Appln. No.: 10/535,569 Amendment Dated: June 15, 2007 MAT-8672US

Reply to Office Action of: March 22, 2007

## **Amendments to the Drawings:**

## **Remarks/Arguments:**

EXHIBIT1

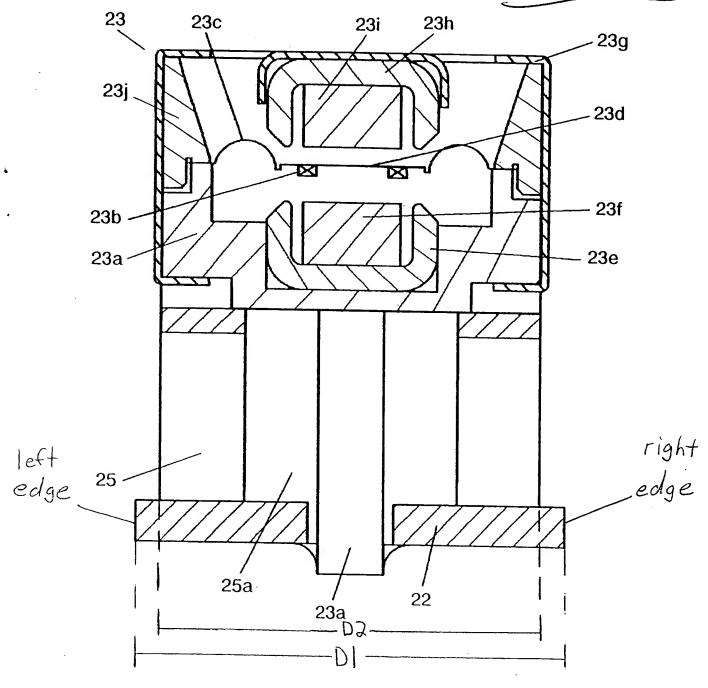
Applicants have enclosed a copy of Applicants' Fig. 2 with markings (Exhibit 1) and a copy of Fig. 1c of Mullenborn et al. (Exhibit 2) to help in explaining the above features. Exhibit 1 corresponds to an exemplary embodiment of the present invention. Exhibits 1 and 2 are being submitted for illustrative purposes only.

Mullenborn et al. includes a plurality of speakers 80A-80D mounted on a printed circuit board 82. The printed circuit board 82 has four edges indicated as top edge, bottom edge, right edge and left edge. None of the speakers 80A-80D, however, "...cover most (D2) of a distance (D1) extending from edge to edge of said printed circuit board 82." For example, as shown at Exhibit 2, speaker 80c covers a distance (D2) from left edge to right edge. However, the distance (D2) is not most of a distance (D1) extending from left edge to right edge. As another example, speaker 80b covers a distance (D2) from top edge to bottom edge. However, the distance (D2) is also not most of a distance (D1) extending from top edge to bottom edge.

In contrast, the exemplary embodiment of Applicants' invention includes a plurality of speakers 23, "...wherein each of said loudspeakers covers most of a distance extending from edge to edge of said printed circuit board." Fig. 1 shows a plurality of speakers 23 mounted on printed circuit board 22. As shown at Exhibit 2, the printed circuit board 22 includes a left edge and a right edge. Each of said speakers 23 covers a distance (D2) that is **most of a distance** (D1) extending from edge to edge (left edge to right edge). This gives Applicants' invention an advantage because a plurality of speakers can be easily manufactured and assembled in a thin and compact manner.
